# CLEVELAND NATIONAL FOREST POWER LINE REPLACEMENT PROJECTS

## MINOR PROJECT REFINEMENT REQUEST FORM

<b>Date Submitted:</b>	05-09-17	<b>Request #:</b>	005	
<b>Date Approval Required:</b>	05-30-17	<b>Landowner:</b>	Various	
<b>APN:</b>	XXX-XXX-XX, XXX-XXX-XX			
<b>Refinement from (check all that apply):</b>				
<input type="checkbox"/> Mitigation Measure	<input type="checkbox"/> APM	<input checked="" type="checkbox"/> Project Description	<input checked="" type="checkbox"/> Drawing	<input type="checkbox"/> Other
<b>Identify source (mitigation measure, project description, etc.):</b>				
<p>San Diego Gas &amp; Electric Company's (SDG&amp;E's) response to Data Request #10 was submitted to the California Public Utilities Commission (CPUC) in April 2015. The data request response included Attachment B.6 C78 Route Map for the Cleveland National Forest Power Line Replacement Projects (Project), which depicted approved facilities, stringing sites, access roads, and anchors for the distribution line. Page B-18 and page B-19 of the Final Environmental Impact Report/Environmental Impact Statement (EIR/EIS) describe the components of Circuit (C) 78, and page B-44 through page B-47 describe th

**Attachment D:  
Comparison Map  
C78 Map 2 of 16**

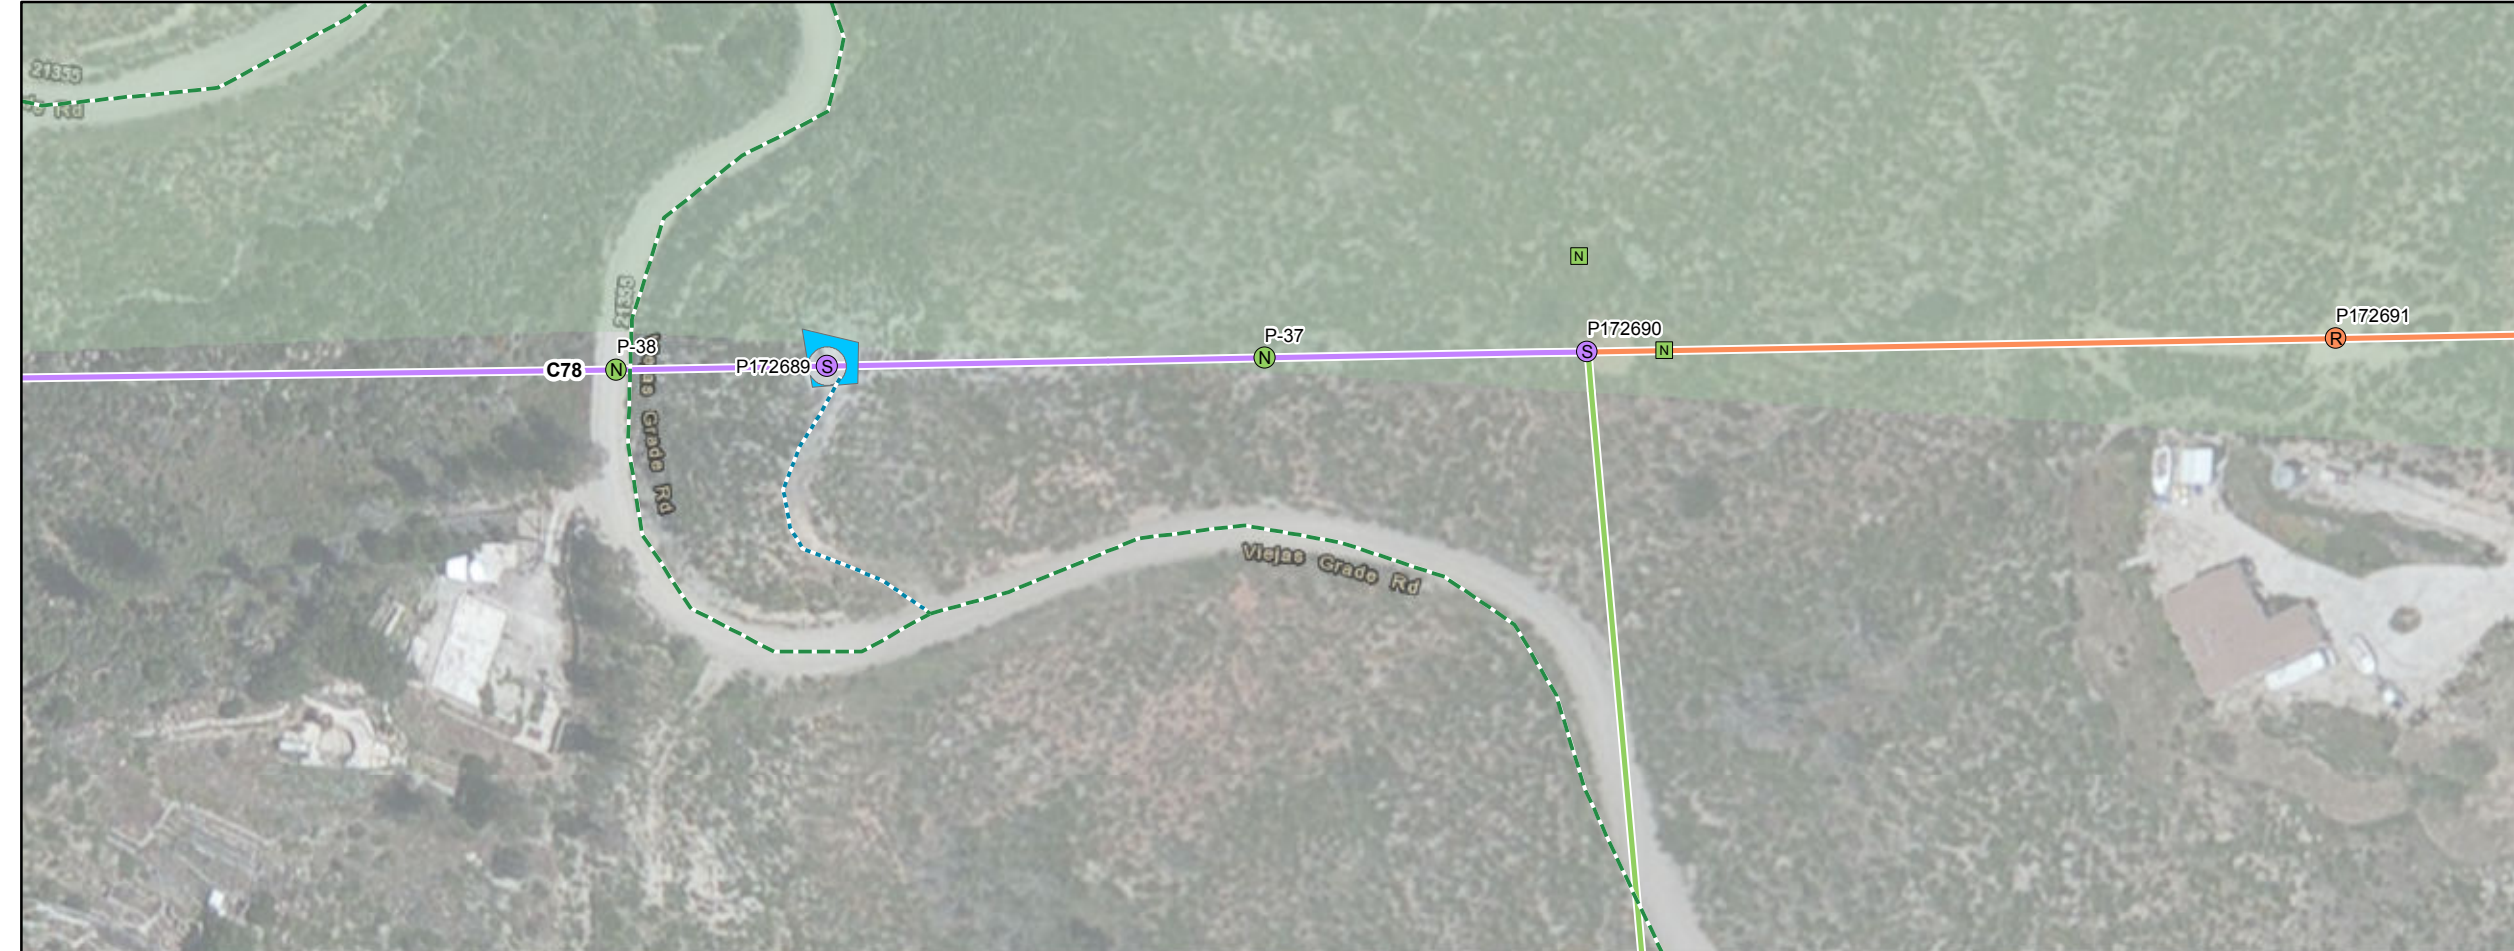
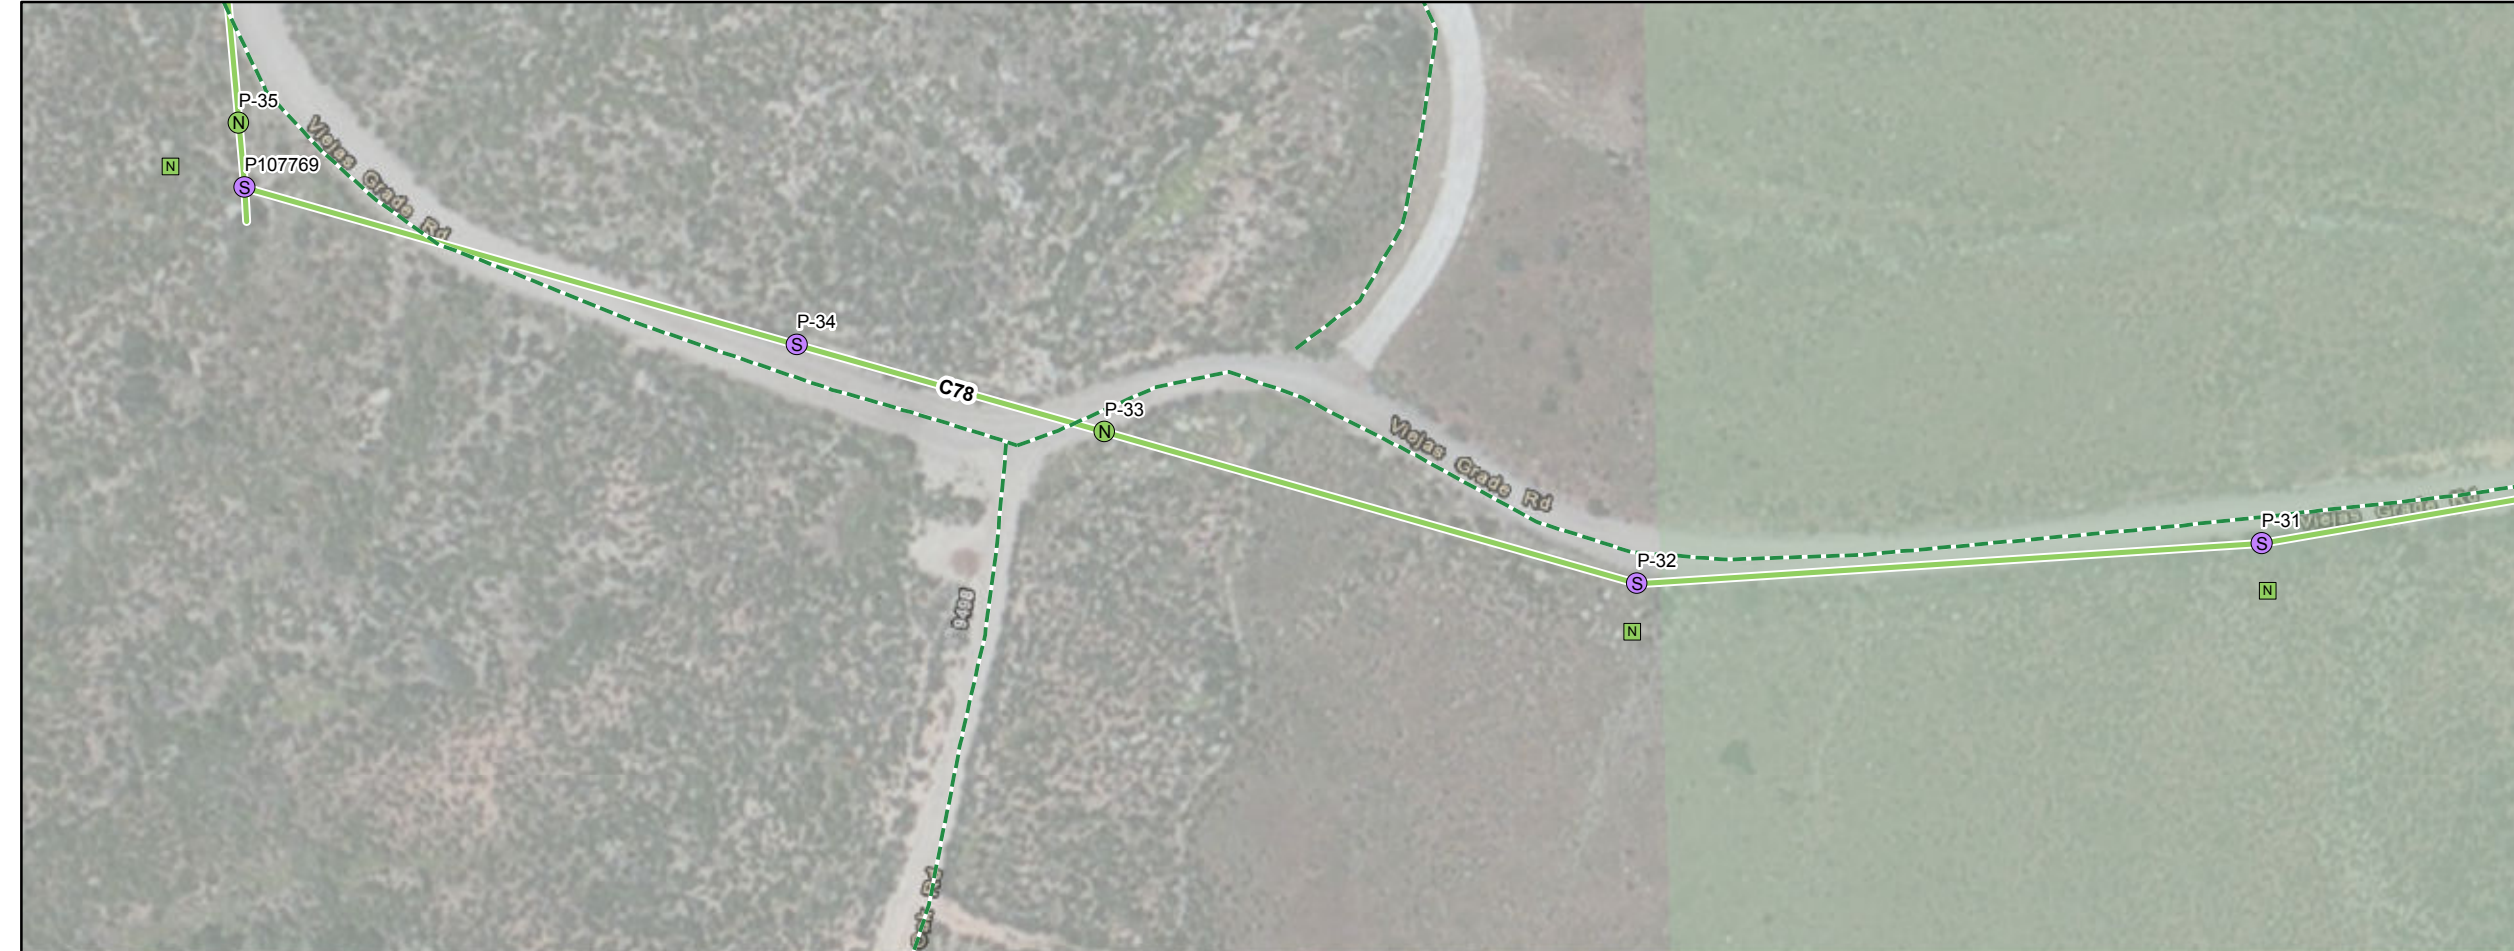
A-10 through A-13	Page 2 of 16	Four new anchors were added in association with P172690	Reinstallation of the anchors are required due to minor relocation and movement of the steel distribution structure. The shift in location of the distribution structure introduces new angles and tension, which in some cases cannot adequately support the change in tension without reinstallation of the anchors.
A-14 and A-15	Page 2 of 16	Two new anchors were added in association with P172691	Reinstallation of the anchors are required due to minor relocation and movement of the steel distribution structure. The shift in location of the distribution structure introduces new angles and tension, which in some cases cannot adequately support the change in tension without reinstallation of the anchors.
A-16	Page 3 of 16	One new anchor was added in association with P257728	Installation of the anchor is required due to the installation of a new steel distribution pole.

P970336	Page 2 of 16	Wood-to-steel replacement of an existing tap pole	Wood-to-steel replacement of the existing tap pole is required due to the minor relocation and movement of the distribution structures. The shifted distribution structures introduce new angles and tension, which requires replacement of the tap pole due to the change in tension.
P-38	Page 2 of 16	Elimination of the proposed new steel pole from the Project	P-38 is no longer needed due to final engineering of C78.
P-37	Page 2 of 16	Elimination of the proposed new steel pole from the Project	P-37 is no longer needed due to final engineering of C78.
P172691	Page 2 of 16	Wood-to-steel replacement of an existing tap pole	Pole P172691, which is an existing tap pole, was proposed for removal in the 2015 baseline data. However, due to the requirements of an existing customer in the area, the pole needs to be replaced.
P107769	Page 3 of 16	Wood-to-steel replacement of an existing tap pole	Pole P107769, which is an existing tap pole, was displayed as a distribution pole and proposed for a wood-to-steel replacement in the 2015 baseline data. The pole will still be a wood-to-steel replacement, but it is now identified as a tap pole.
